COUNCIL ASSESSMENT REPORT

Panel Reference	PPSSCC-241
DA Number	DA 1541/2021/JP
LGA	The Hills Shire Council
Proposed Development	Mixed Use Development Comprising of Two Residential Flat Buildings Containing 196 Apartments, Retail, Business, Indoor Recreation and Medical Uses and Basement Car parking
Street Address	40 Solent Circuit Norwest
Applicant/Owner	Mulpha Norwest Pty Ltd
Consultant/s	Calibre Professional Services – Planner Bates Smart and Smart Design Studio – Architects Aspect Studio – Landscape Design Australis Tree Management – Arborist Report Stantec – Civil Engineering and Stormwater Management Gennaoui Consulting – Traffic and Parking Douglas Partners – Geotechnical Assessment and Contamination Report Advisan – Site Investigation and Heritage Impact Statement McKenzie Group – BCA Assessment and Accessibility Report ADP Consulting – Acoustic, Infrastructure and BASIX Report Windtech – Pedestrian Wind Environment Statement Elephants Foot – Waste Management Finding Infinity – ESD Statement Core Engineering Group – Fire Safety Engineer MBM – Quantity Surveyors Report

consideration	
Report prepared by	Cynthia Dugan - Principal Coordinator Development Assessment
Report date

b. Building Separation

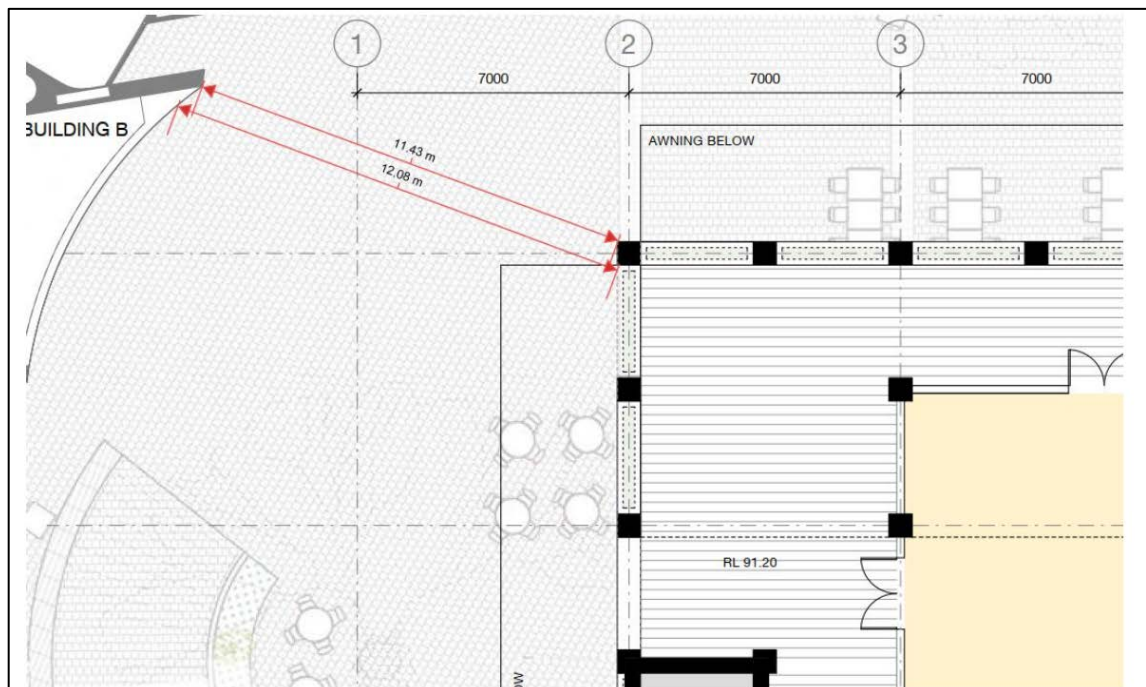
The Apartment Design requires that for habitable rooms and balconies, a 12m separation is required for 4 storeys, 18m for 5-8 storeys and 24m for 9+ storeys.

The proposal complies with building separation requirements to buildings external to the site however the internal building separation between the podium level of Building C and the first four storeys of Building B is 11.4m (where 12m is required).

Figure 1

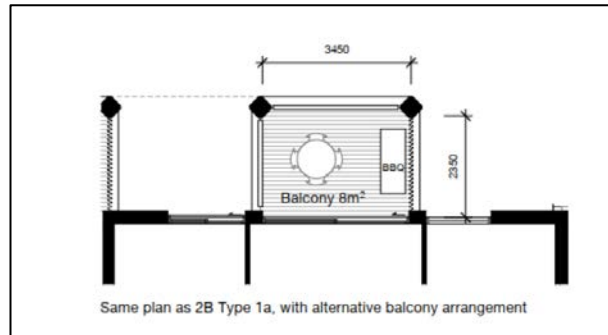
2 Bedroom Type 1c – have internal areas of 79m². The non-compliance is a minor variation of 2m² to only 5 units of this type and occurs every third level, as part of the articulation of the northern façade of Building C. This balcony has a depth of 2.35m which exceeds the 2m minimum depth required.

Figure 2

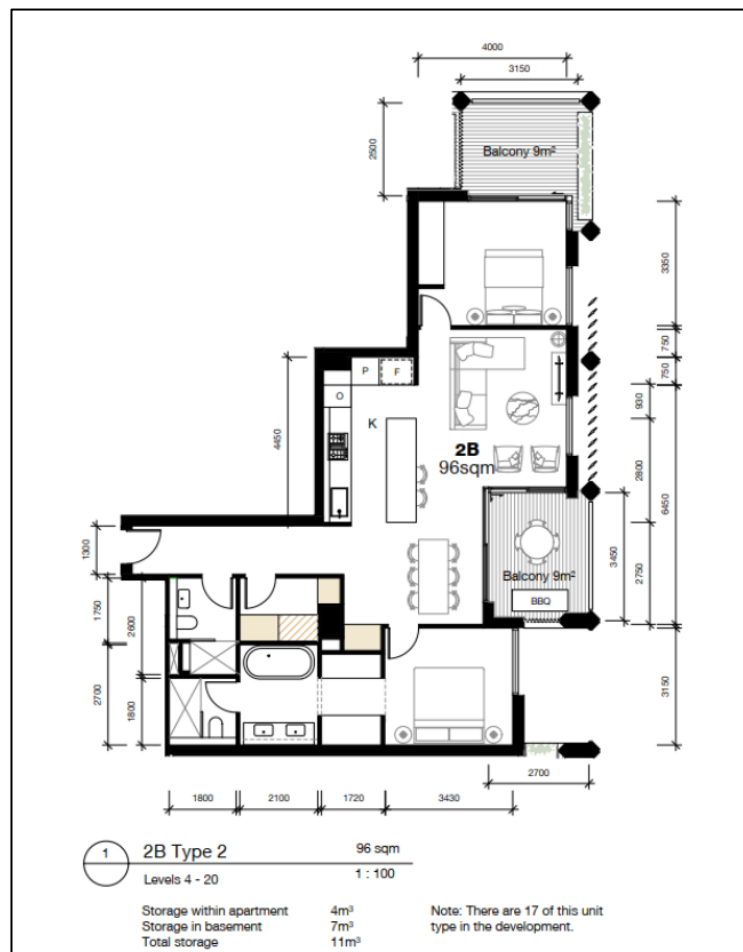
2 Bedroom Type 2 – has a usable balcony area of 9m² off the living room, which is a minor 1m² variation to the minimum of 10m², for 17 units of this type. This apartment type however has an additional secondary balcony off a bedroom which has a useable area of 8m². This balcony has a depth of 2.7m which exceeds the minimum 2m required.

Figure 3 East precinct building layout plan

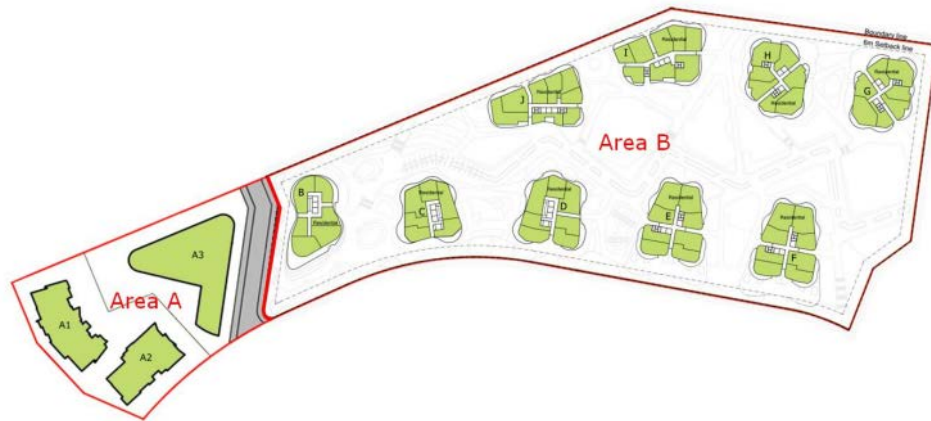
The proposal is generally in accordance with the above figure however the building envelopes are more rectilinear and the podium for Building C is wider than as shown above.

It is considered that despite the variation to the building envelopes under Figure 3 of Appendix 1, the proposal still meet the objectives of the control and the variation can be supported.

Figure 5 East precinct common open space plan

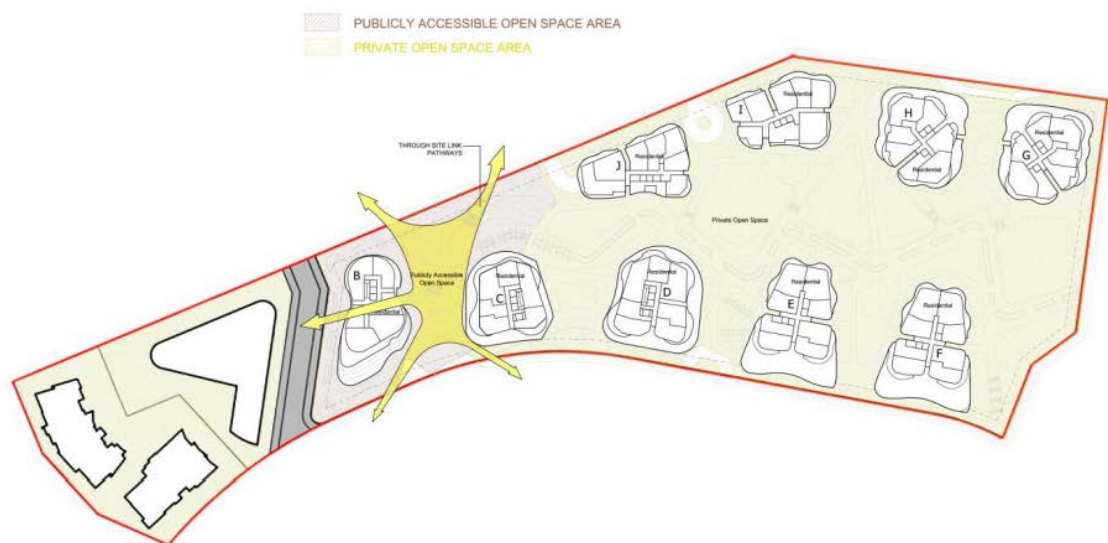
The site rises steeply from Solent Circuit to Spurway Drive with the highest point being approximately 10m above on Spurway Drive. It is considered that the site planning and development relates to the natural contours of the site as the obligations under the VPA require a pedestrian link to connect Solent Circuit and Spurway Drive and provide a publically accessible easement on the ground plane within the Stage 1 development site. It is noted that Stage 1 encompasses all the non-residential land uses including restaurants/cafes, shops, business premises and a gymnasium to activate the lower levels of the buildings and includes a ground level publicly accessible open space area of 5,751m². This is consistent with East precinct common open space plan in Figure 5 of the DCP.

The extension of the podium for Building C results in the provision of private communal open space for future residents including a pool which would provide for better residential amenity. The podium also provides for a better connection with the pedestrian link including an internal lift access and open air forecourt leading into the proposed supermarket. The proposed building envelope for Building C also provides more opportunities for public communal open space to the north.

Figure 5: Building B plan indicating point encroachments to Solent Circuit front setback control.

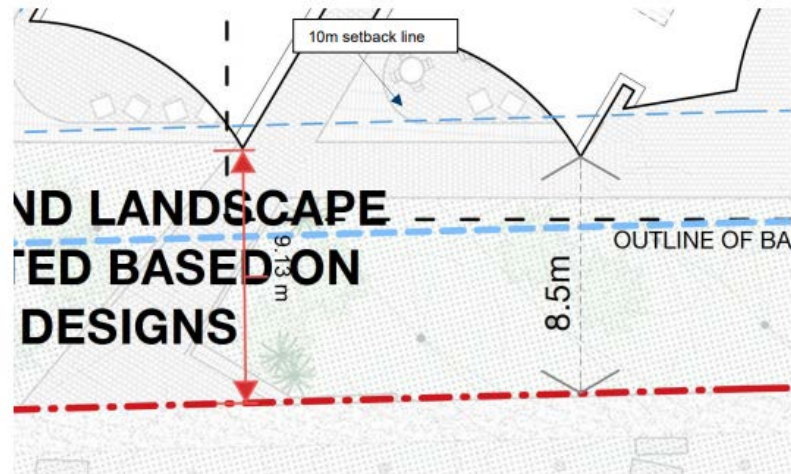
Building B generally complies with the front setbacks controls with the exception of point encroachments for the tower element on Solent Circuit and Spurway Drive and a further encroachment for two circular podiums fronting Spurway Drive. The extent of variations are depicted in the below figures.

It is considered that these encroachments are minor in nature and add to the architectural diversity of the building. The variations are consistent with surrounding residential flat buildings approved on Spurway Drive which comprise 6m front setbacks as highlighted below:

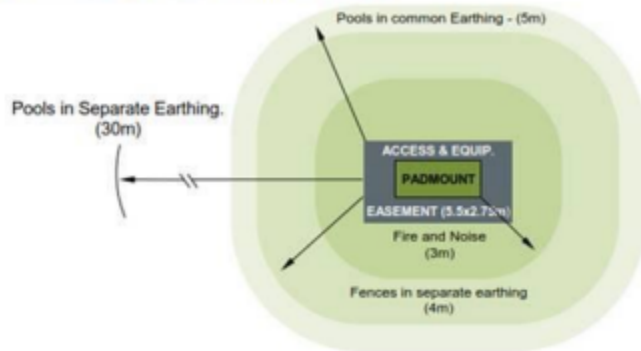
The proposed padmount substation location to the Solent Circuit road frontage is shown in the following extract of the Architectural Plans.

From Endeavour Energy's perspective the fact that provision is being made for a padmount substation is a positive. Endeavour Energy's general requirements is for a padmount substation to be at ground level and have direct access from a public street (unless provided with appropriate easements for the associated underground cables and right of access).
